RE: 1105 Front Street NE – The Cannery (Reference No. 24-106451-PLN) Completeness Response

Reference Nos.: 24-106451-PLN (Class 3 Site Plan Review, Tentative Subdivision Plan, Class 1 & 2 Adjustment, Class 2 Driveway Approach Permit)

PRELIMINARY SITE PLAN
THE CANNERY
FUND
SALEM, OREGON

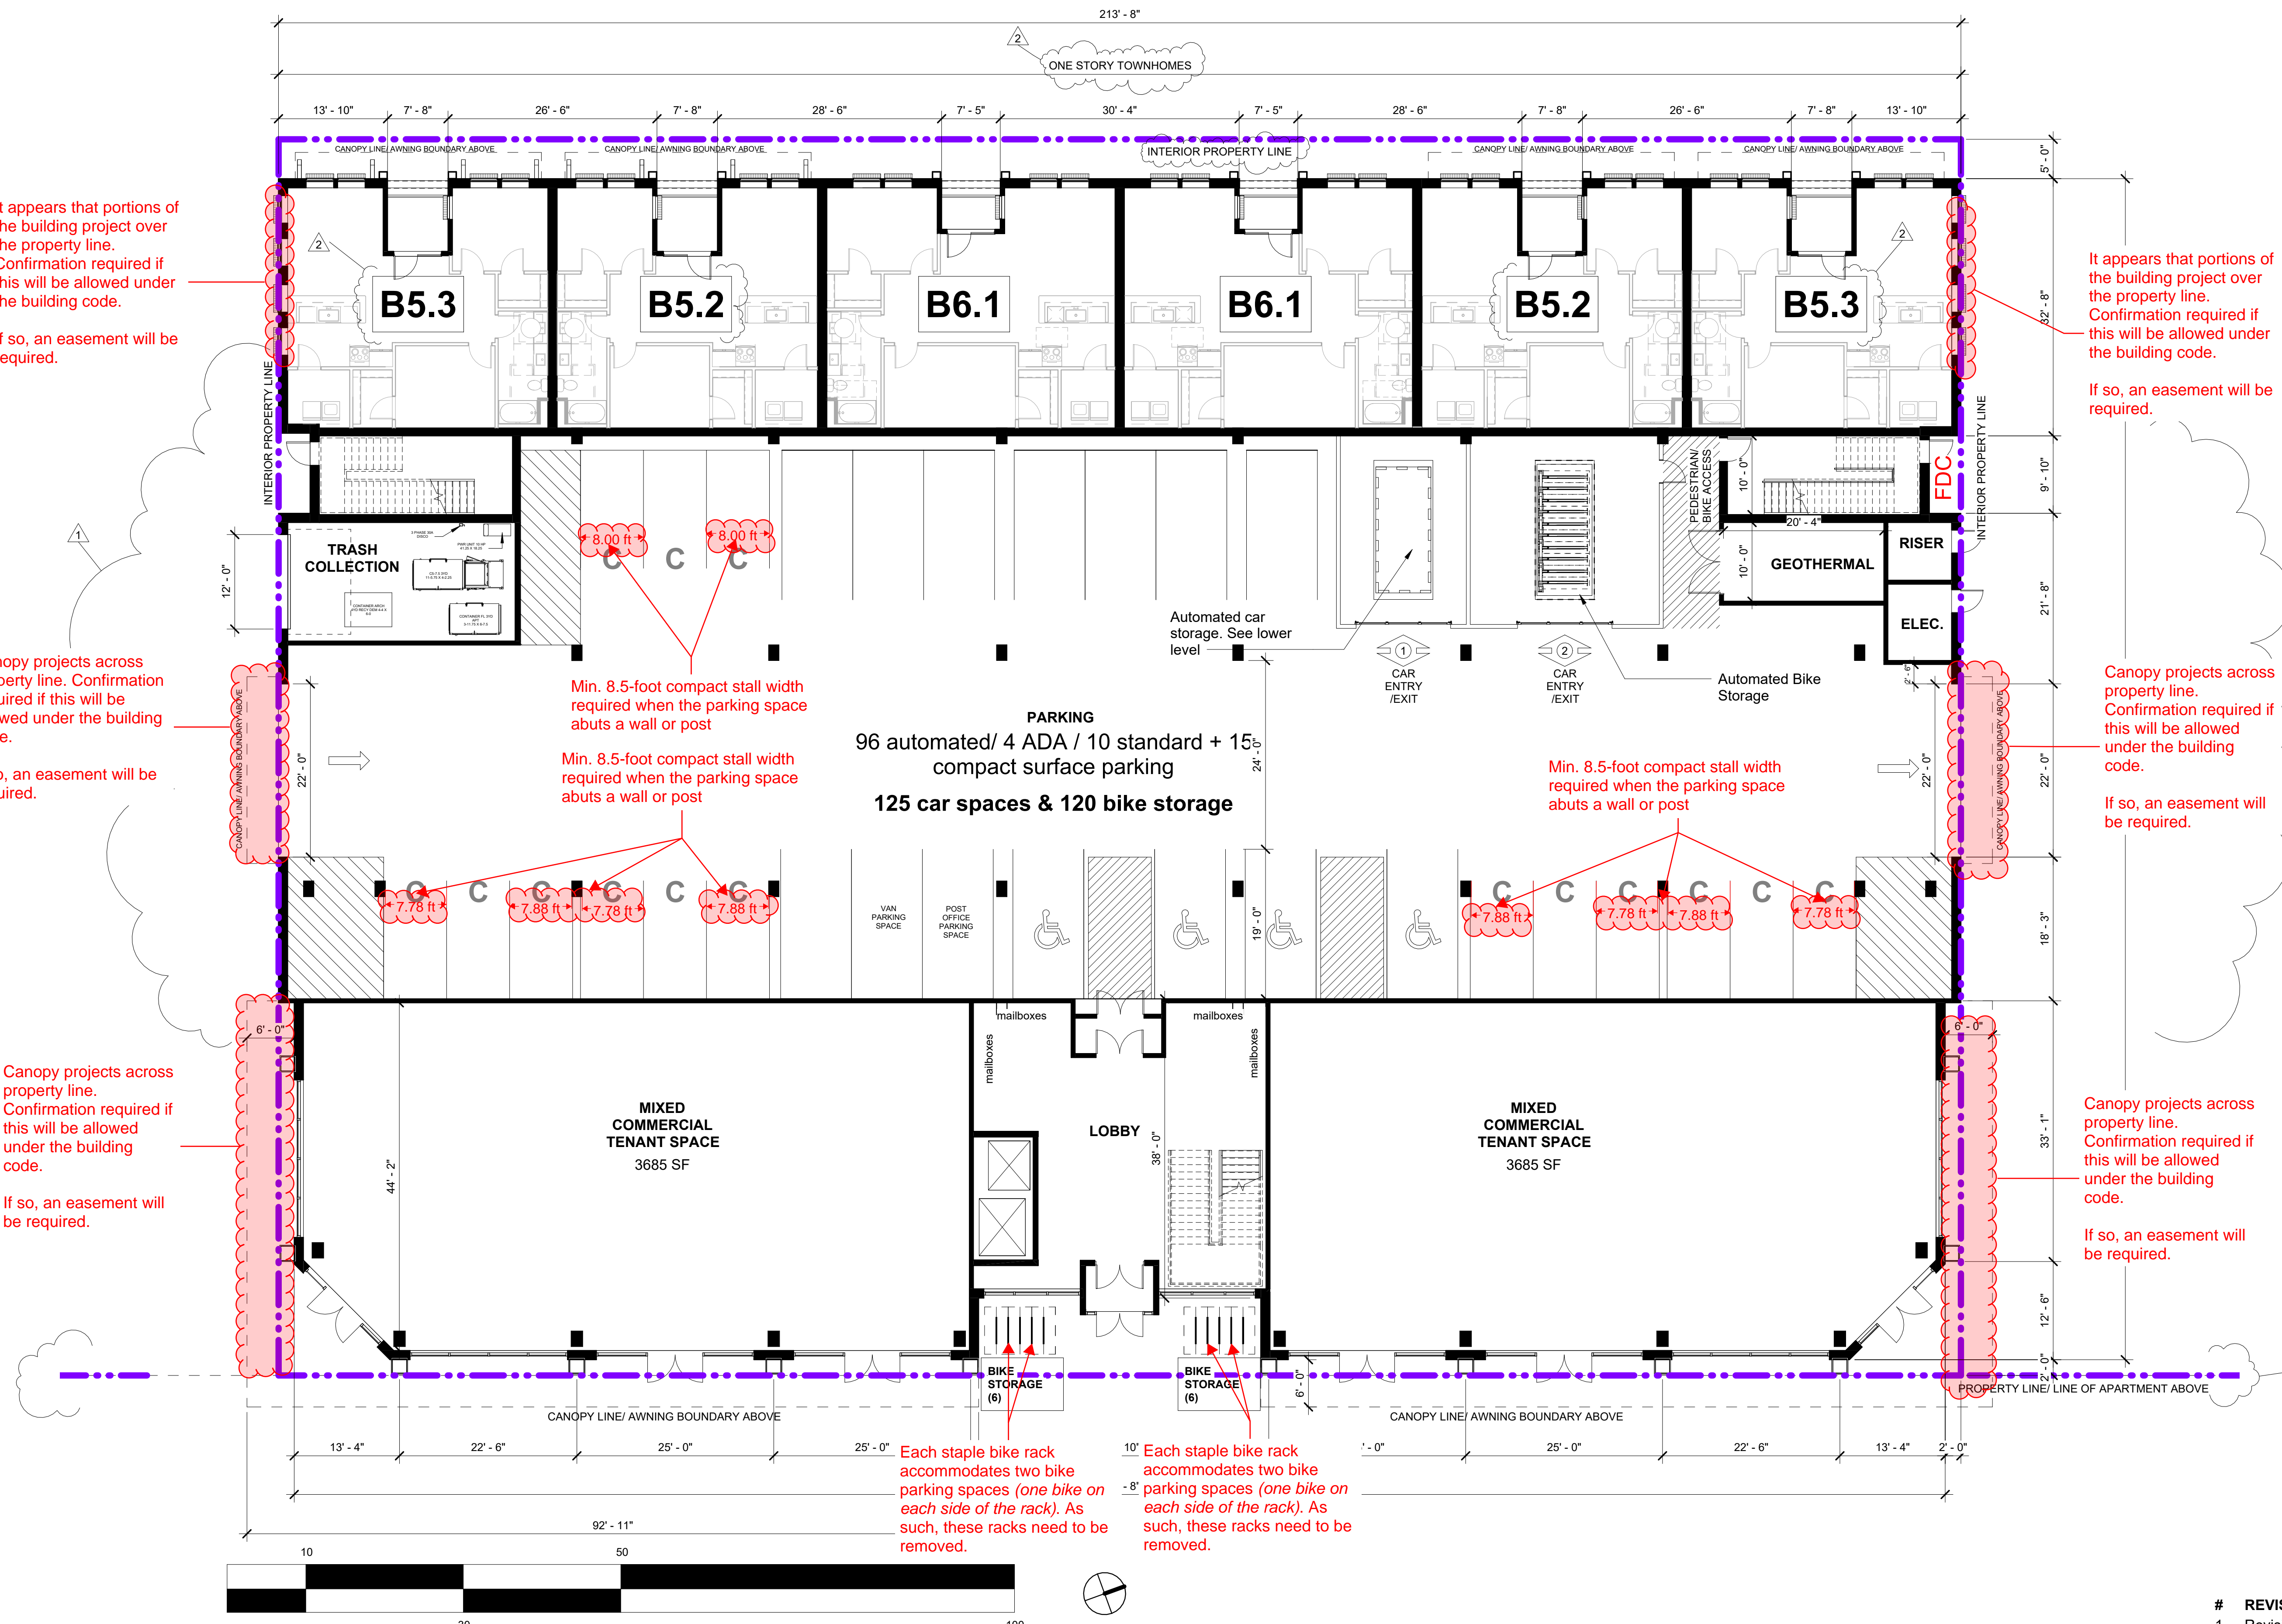
It appears that portions of the building project over the property line. Confirmation required if this will be allowed under the building code.
If so, an easement will be required.

It appears that portions of the building project over the property line. Confirmation required if this will be allowed under the building code.
If so, an easement will be required.

Response: Planned property lines have been modified such that no canopies, balconies, or living space project across a property line as detailed on the revised Preliminary Building Elevations and Floor Plans in Attachment E. The 6th floor living space that projected into the Front Street NE right-of-way has been modified. This item is met.

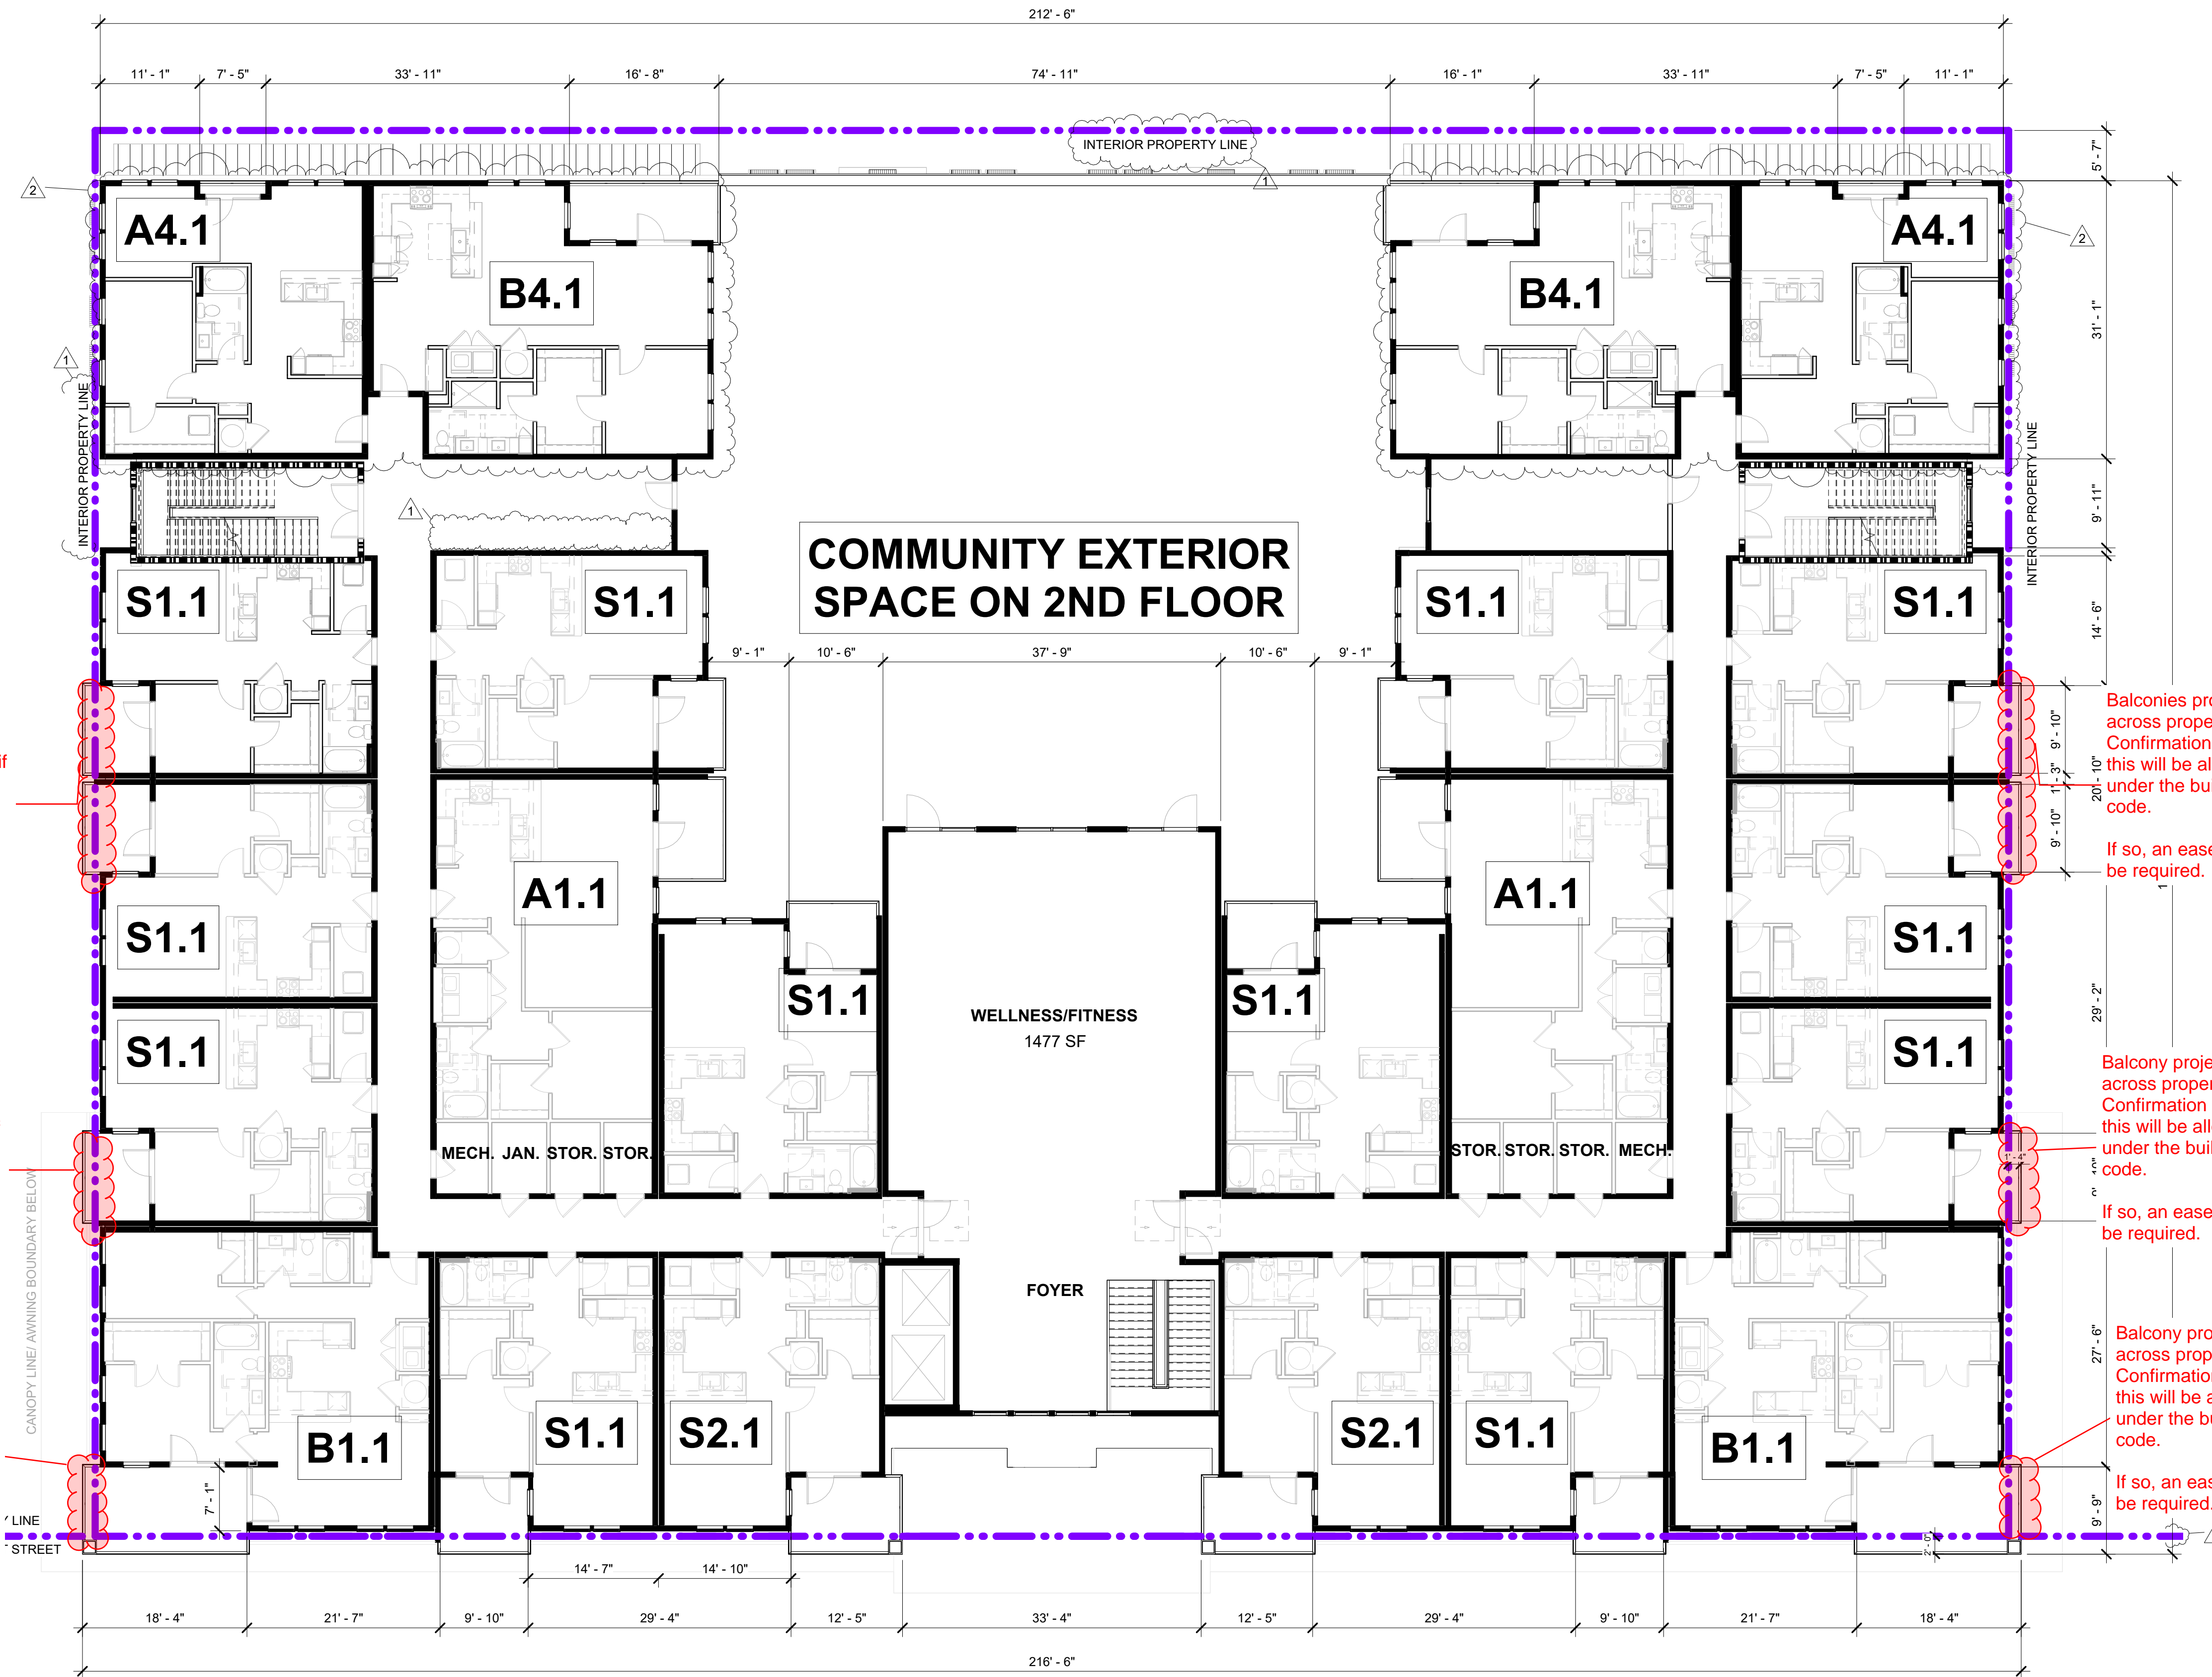
Balconies project across property line. Confirmation required if this will be allowed under the building code.
If so, an easement will be required.
